INDIANA DEPARTMENT OF TRANSPORTATION

STANDARDS COMMITTEE MEETING

May 21, 2009 Standards Committee Meeting

RE: Agenda for the May 21, 2009 Standards Committee Meeting

802-SNGP-01 SIGN PLACEMENT

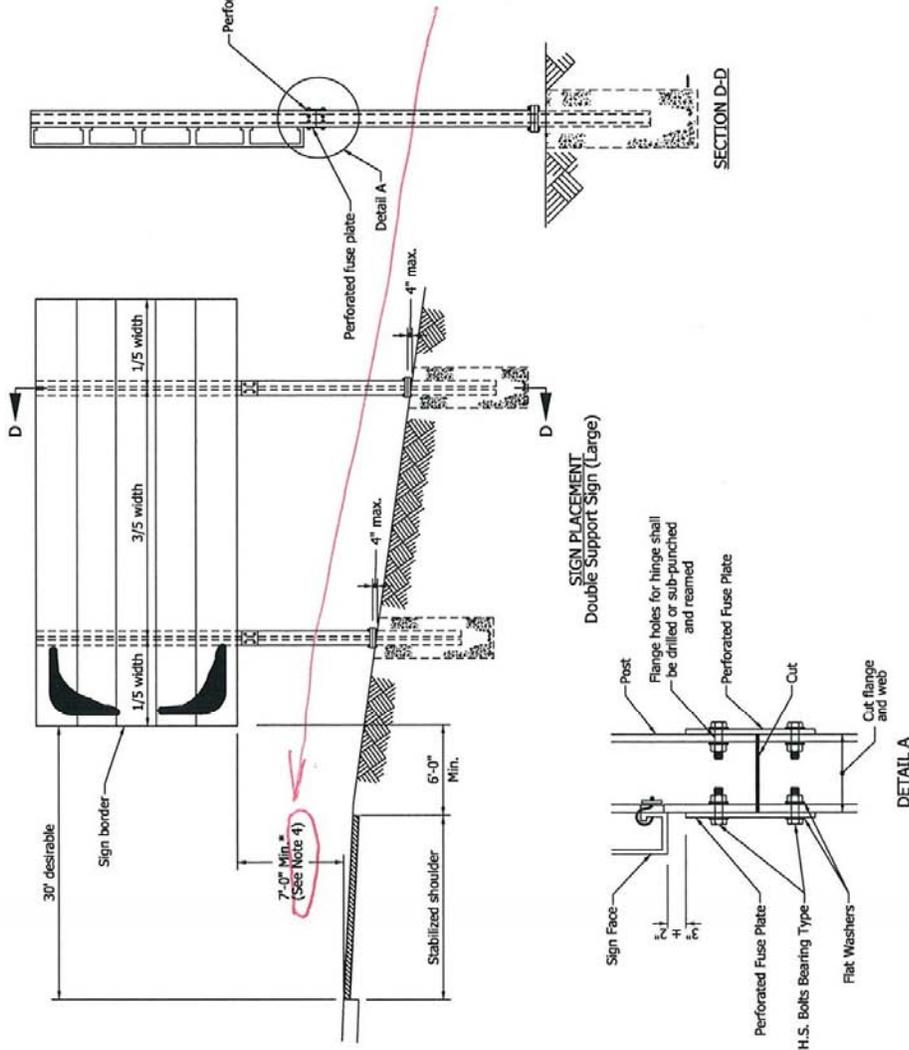
During the last meeting with District Traffic Engineers a question was raised about this Standard Drawing and it was pointed out that this present Standard Drawing 802-SNGP-01 does not give the details about the minimum height of the panel sign above the ground in case of up slope or elevated ground. This Standard Drawing gives the details about mounting height of the panel sign for down slopes only.

I am proposing a change in this Standard Drawing. The change being proposed is only an addition in the notes stating that "in case of up slope or elevated ground, the bottom of the outer edge of the panel sign shall be 7 ft. min. above ground."

1. No more than one W10 x 19 or larger post can be used in a 7'-0" path. No more than two W8 x 18 or smaller posts can be used in a 7'-0" path.
2. For 3 post installation, the edge of sign to post is 1/6 width of sign and 1/3 width of sign between posts.
3. See E 802-SNGP-04 for base plate details.
4. In case of up slope or elevated ground, the bottom of the outer edge of the panel sign shall be 7'-0" min. above ground.

- 806-SGFB-03 PEDESTAL MOUNTED SOLAR POWERED SCHOOL FLASHER
- 806-SGFB-04 PEDESTAL MOUNTED SOLAR POWERED WARNING FLASHER

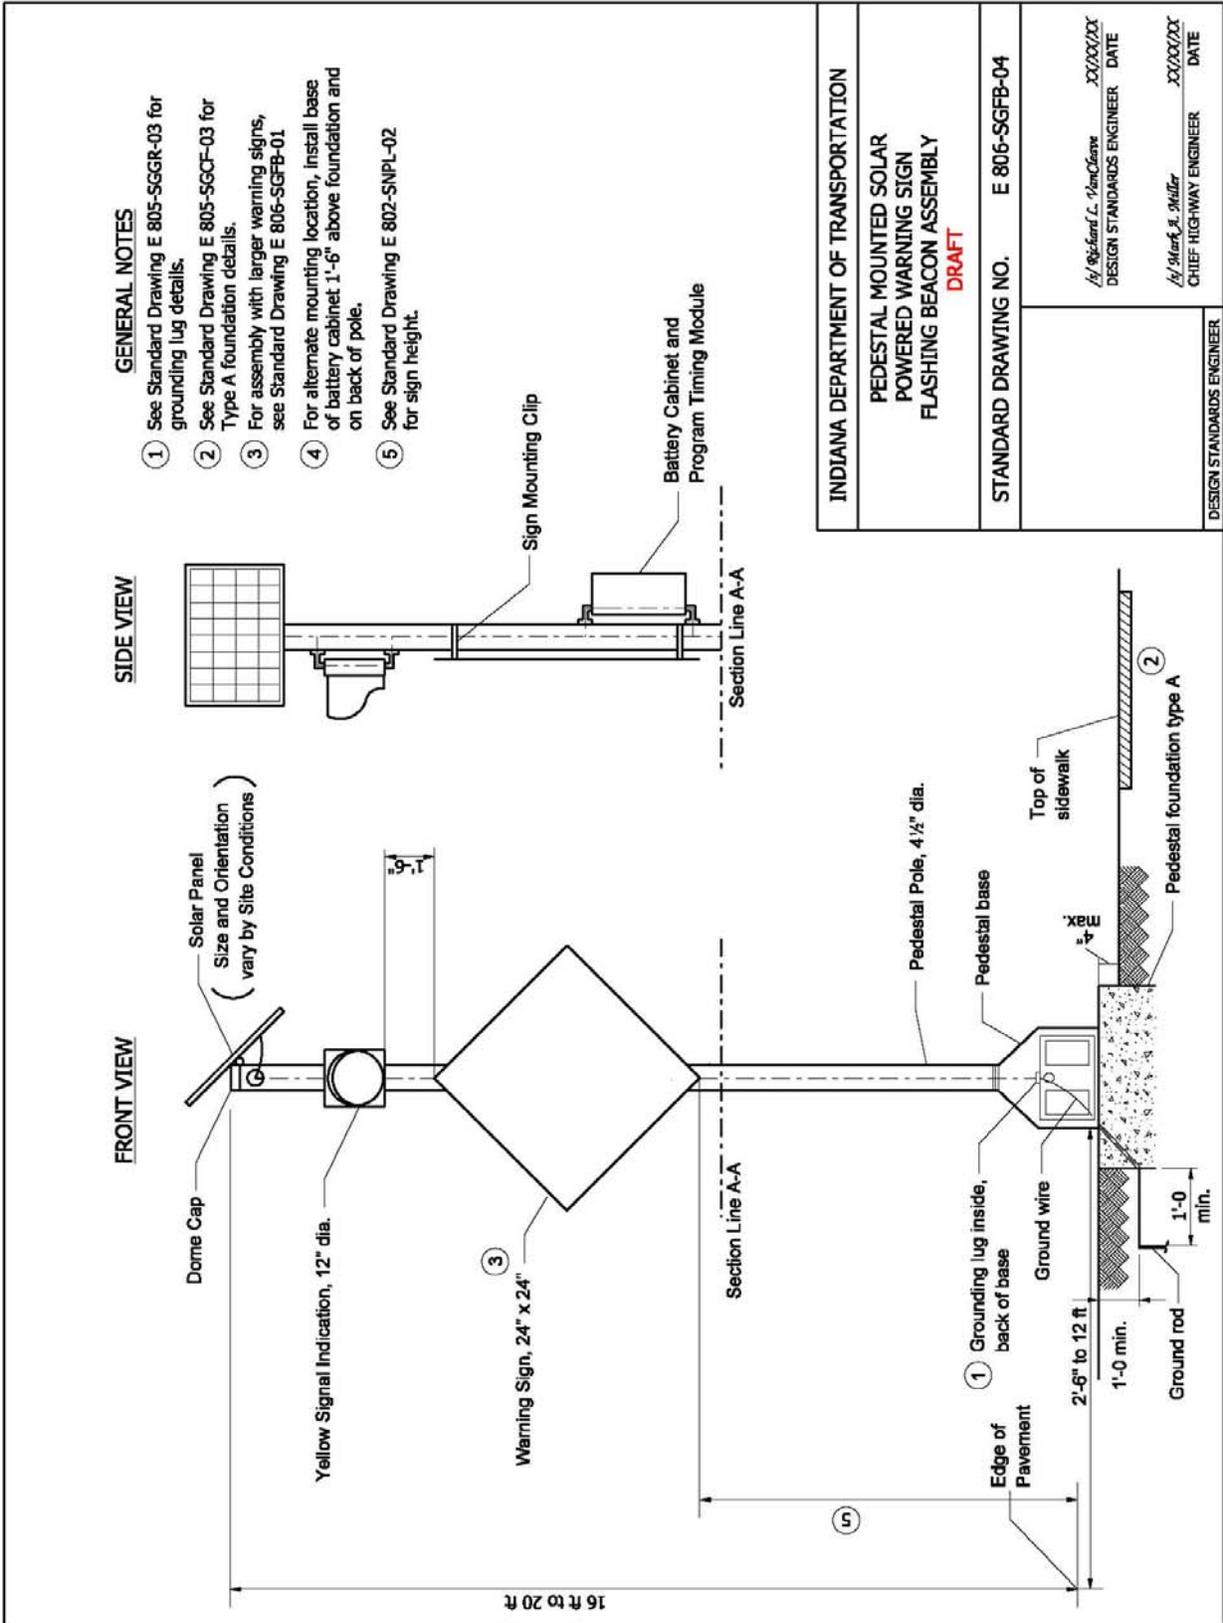
Due to the increasing use of solar-powered flashing beacons in rural areas, the district traffic engineers requested that a specification and standard drawing be developed for this type of traffic control device.

The proposed solution involves two standard drawings and four additional specifications to the 800's section of the spec book.

Figure 52-13F

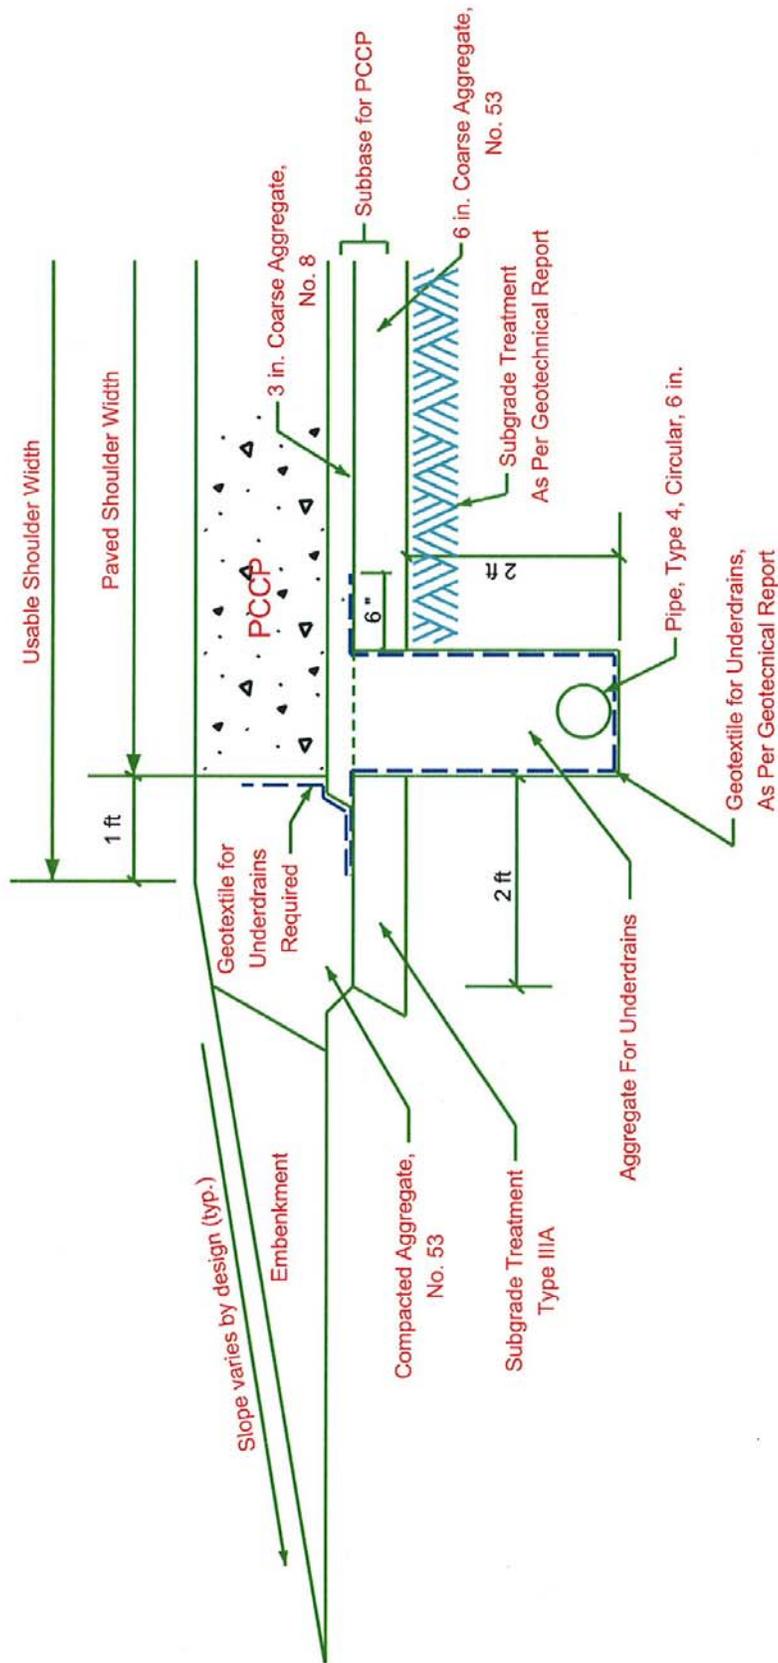
PROBLEM(S) ENCOUNTERED: Revised IDM PCCP Typical Section. Executive Office efforts to reduce Construction costs resulted in the generation of Pavement Cost Savings Proposition #08002.

PROPOSED SOLUTION: Revised Typical Section will save approximately \$64,000.00 per mile of 4 lane divided highway. Savings will be realized by minimizing aggregate wedge at edge of shoulder and by eliminating compacted aggregate placed for the sole purpose of providing a construction platform for the paver tracks and replacing it with Subgrade Treatment Type IIIA.
